Plan Review Discrepancy Report Reply Letter

Sequoia Orchard Park, Lee's Summit, MO Permit # PRES20240700

SEQUOIA DUPLEX ALT #1
205 & 207 Orchard Court
LEE'S SUMMIT, MO

A102

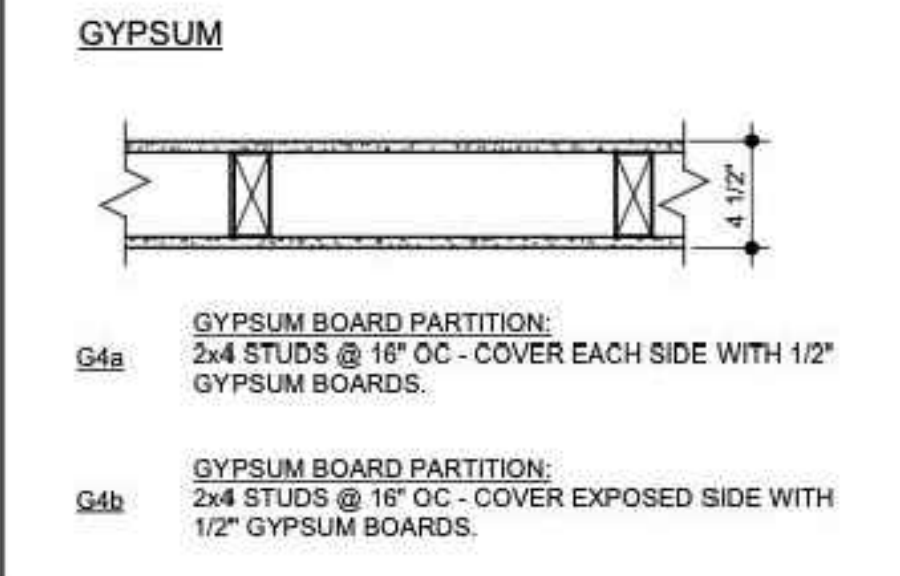
ITEM #1 The square footages are placed on the top of sheet A102 and are in both Gross and Net areas and I am sending an updated Application Form that will match the areas together from what the final plans show.
